Evaluation of Community Proposals for LAX North Downwind Arrival Routes

Presentation to LAX/Community Noise Roundtable
January 8, 2020

Conduct technical assessment and noise/emissions evaluation for two proposed alternate LAX North Downwind Arrival Routes

Community Proposal – Option A Proposed Route

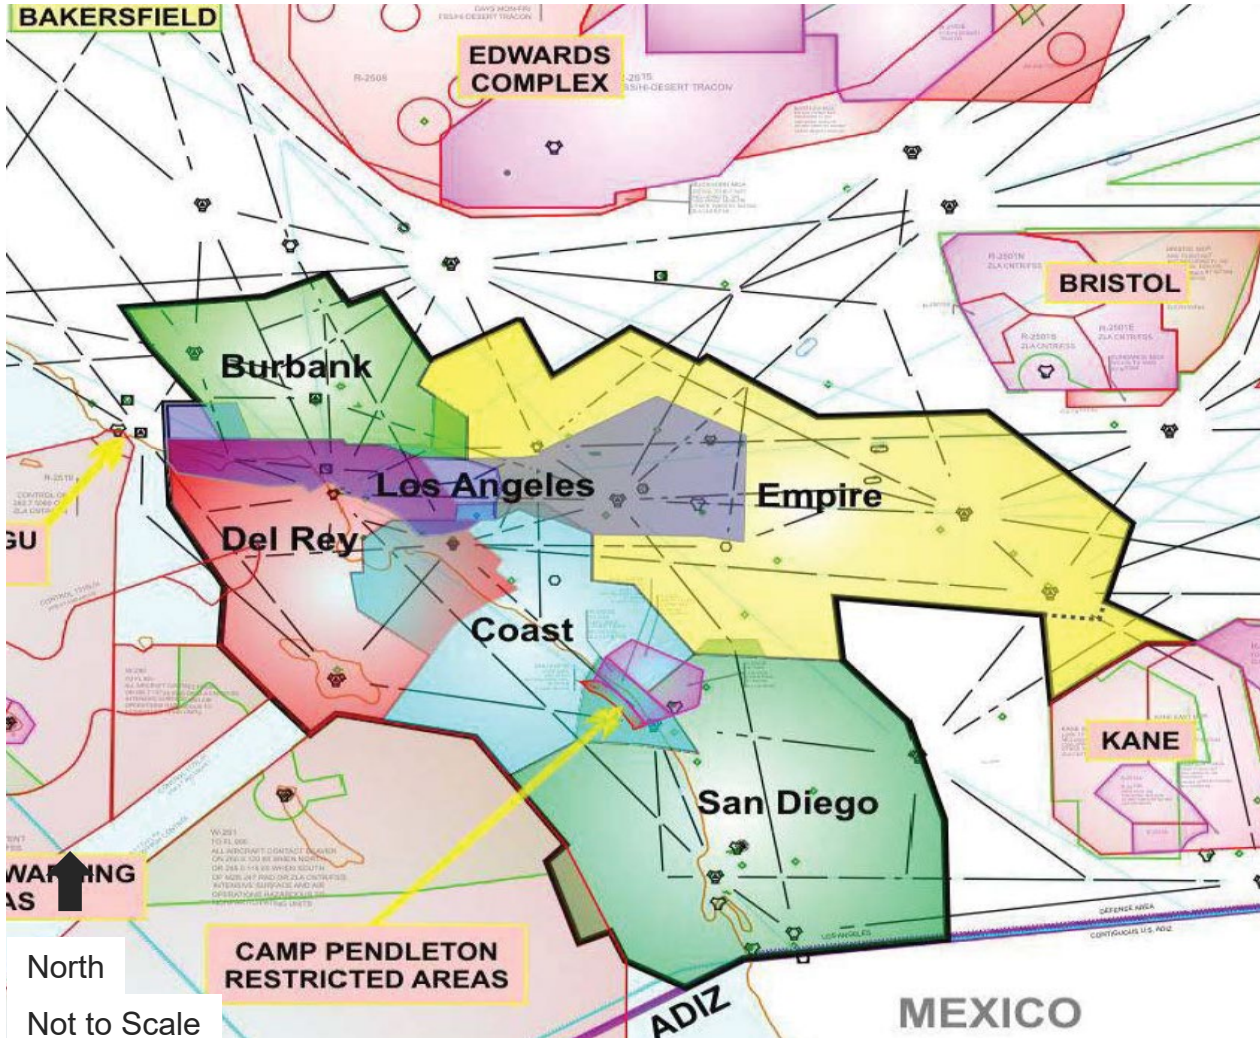
- Aircraft flying farther east and turning for final approach in San Bernardino County
- Raising aircraft altitudes
 - Existing and Proposed waypoint altitudes shown in green

Option A: Task 1 - Technical Assessment

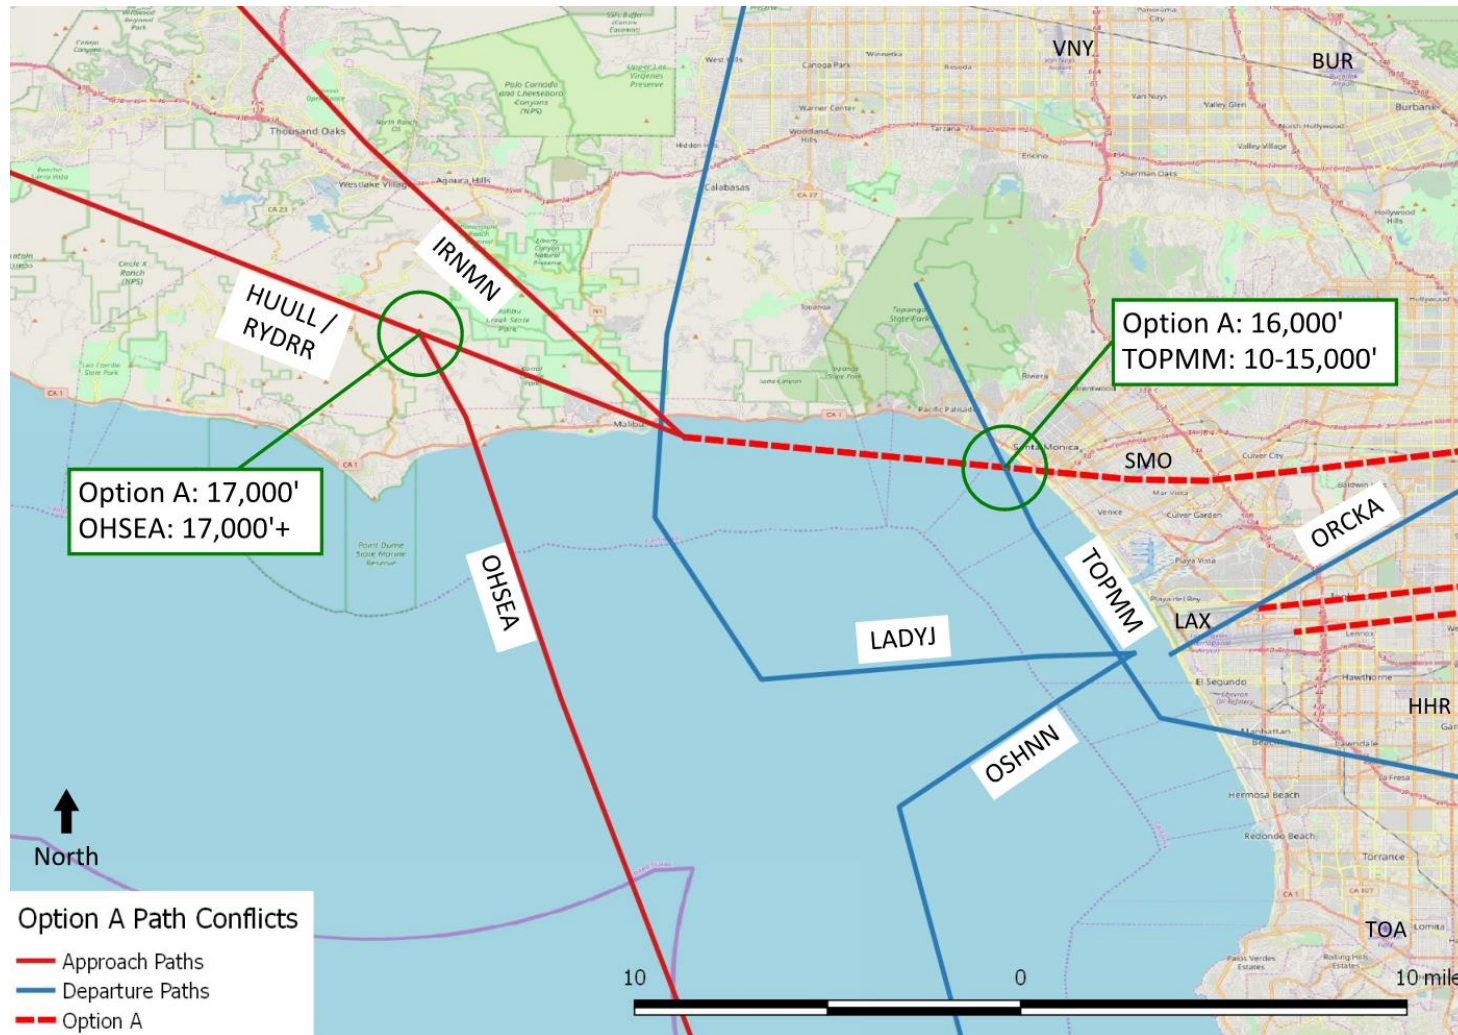
- OHSEA: John Wayne (SNA)/Long Beach (LGB) Arrival
- TOPMM: Long Beach (LGB) Departure

Option A: Task 1 - Technical Assessment

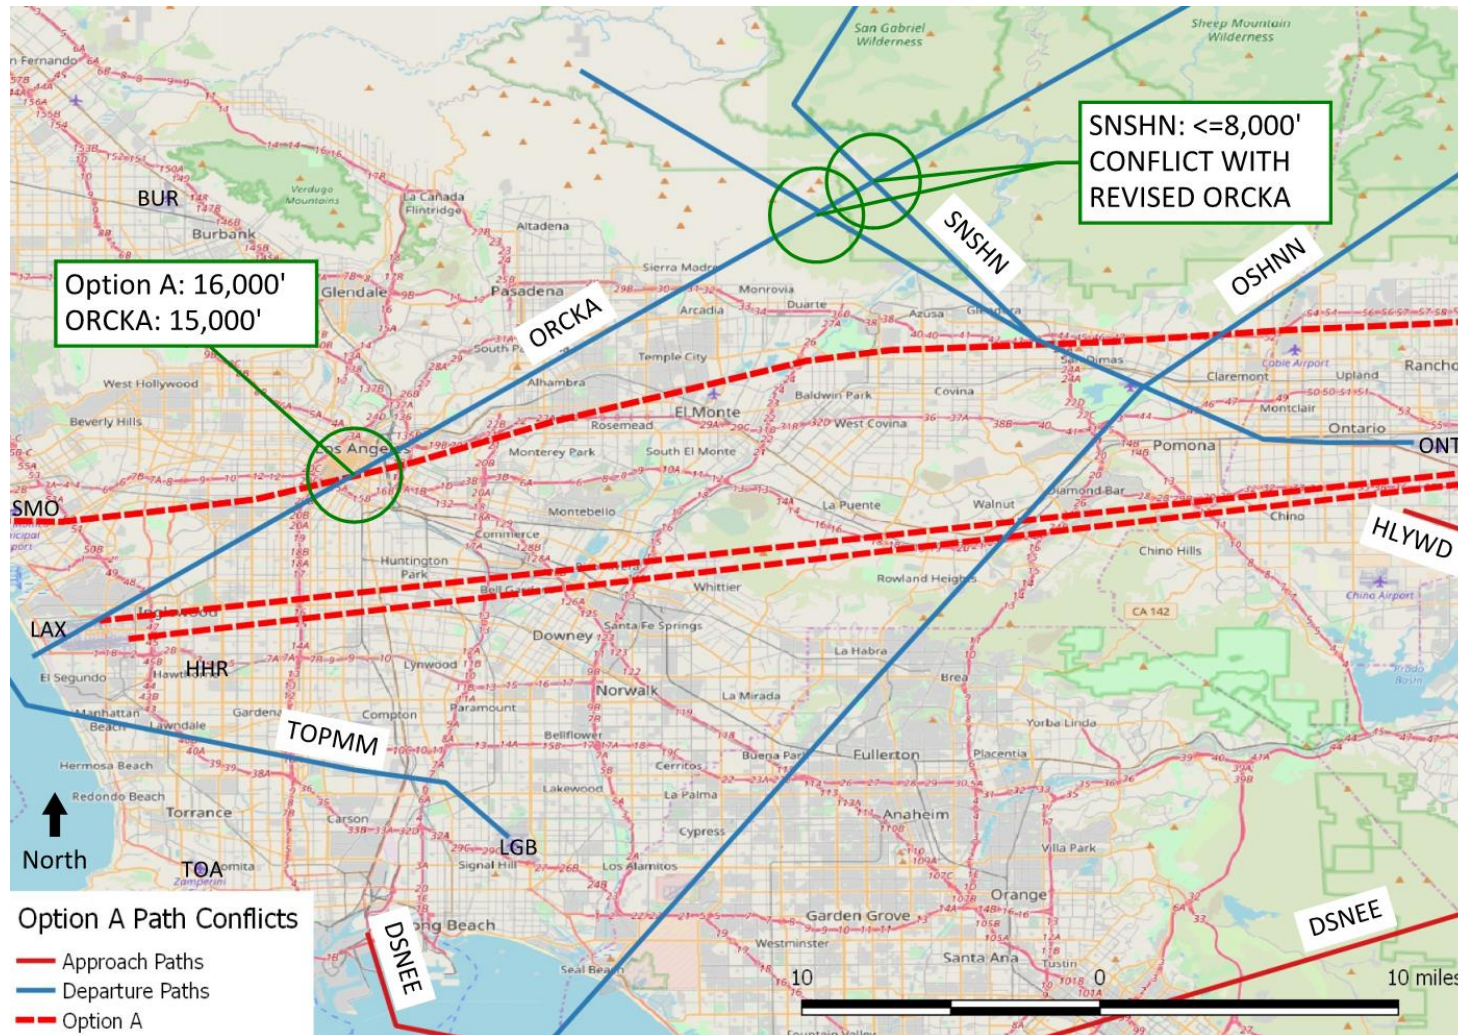
- ORKCA: LAX Departure
- SNSHN: Ontario (ONT) Departure will conflict with revised ORCKA

Option A: Task 2 - Noise Assessment

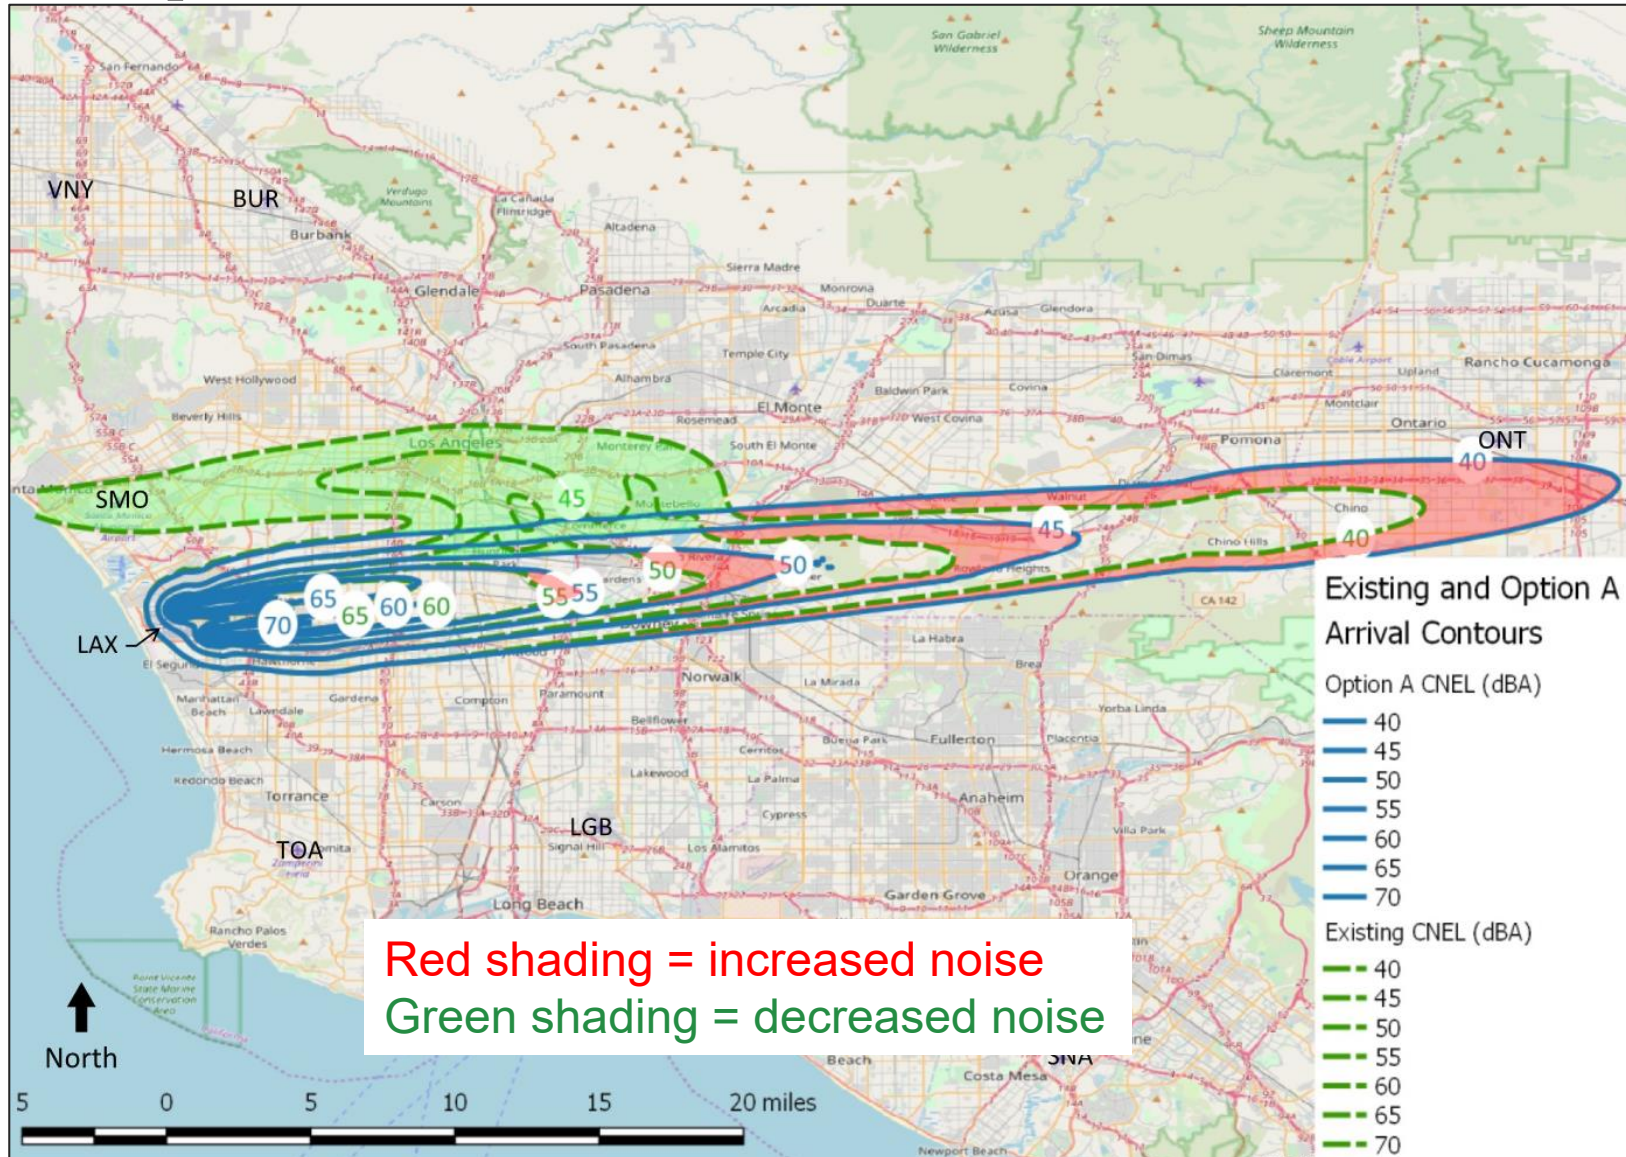
- Decrease of noise for communities along existing north downwind route
- Increase of noise for communities farther east
- Not consistent with the Roundtable's no shifting of noise policy

Option B: Task 1 - Technical Assessment

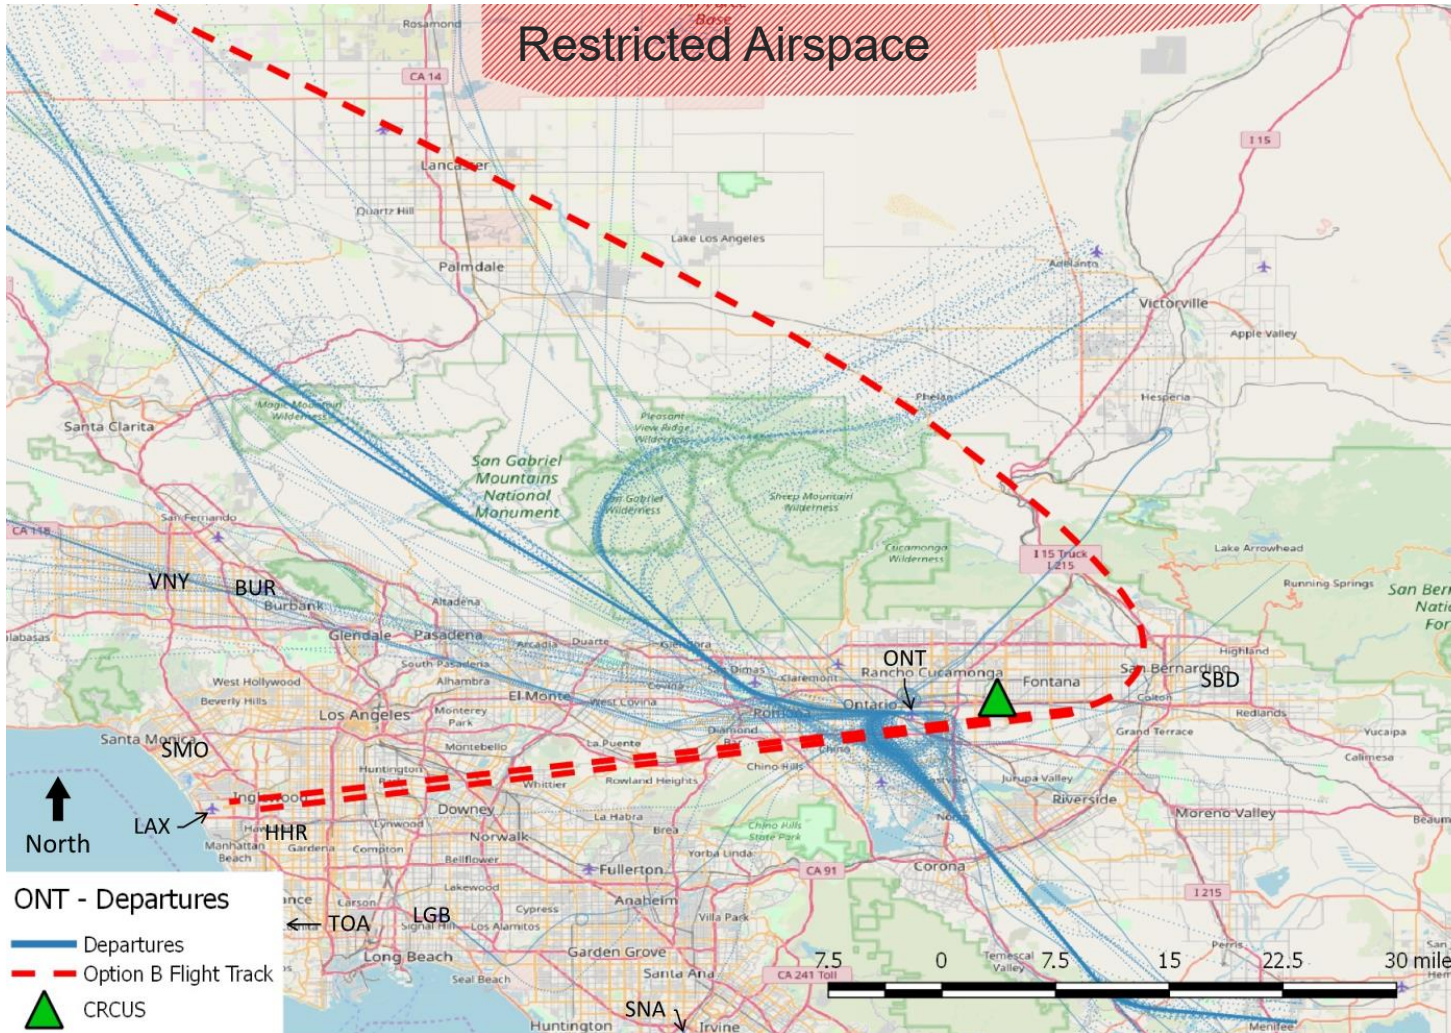
- Increased controller/Traffic Management workload (Controller now has to sequence Option B arrivals with East arrivals)
- Increased usage/congestion of Class B / C airspace
- Increased cockpit workload (flight time, +60 nm for N arrivals, +110 nm for Oceanic arrivals)
- Revised LAX arrival/departure procedures required W/NW of Airport
- Not all flights could/would use Option B (e.g., oceanic from Asia/HI)
